JN: 193425

Re: 445-459 Canterbury Road Campsie – Private Hospital development
Stormwater advice

Figure showing potential WSUD locations within the site – shown in blue.

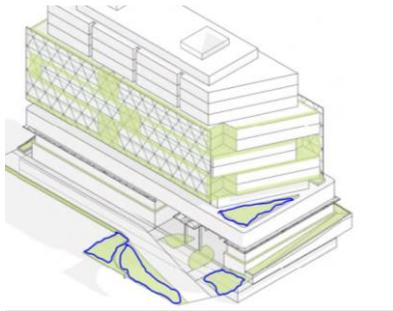
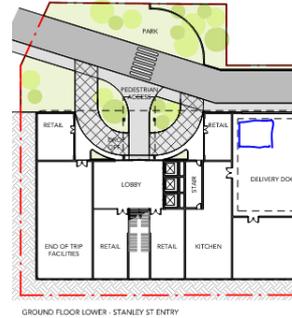
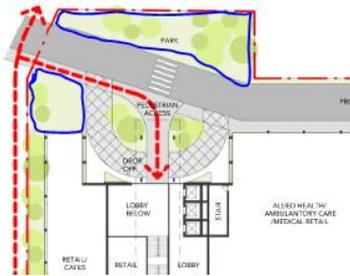
- Water Sensitive Urban Design (WSUD) elements were not discussed in the planning proposal report. It is recommended to incorporate WSUD elements where possible throughout the development site. Please provide appropriate WSUD principles and controls to inform the DCP
- It is desirable that the provision of on-site/localised water recycling facility to support sustainability should be considered to provide recycled water for all toilet flushing, clothes washing, irrigation etc. Please provide details for inclusion in the future DCP.
- Demonstrate how the proposal will maximise deep soil provision at 15% of the site and achieve 5% tree canopy cover across the subject site. The DCP should specify minimum deep soil areas and minimum deep soil area widths.

On the LHS is area where drainage can be combined with landscaped areas.

On the RHS is areas within the building where a WSUD tank could be located.

In areas where drainage is combined with landscaping, the result would be a raingarden. This would require the garden to be sculpted as a depression where drainage water can pond and infiltrate into the soil profile. Water in excess of the capacity of this feature would overflow into the local drainage network, i.e. the street.

If the raingarden areas cannot be used due to other constraints, a tanked area would need to be provided in the building – either on the lower ground floor, or in the basement. Within the tank would be located a proprietary water quality filter device, e.g. Oceanguard’s Stormfilter. Both are shown below.
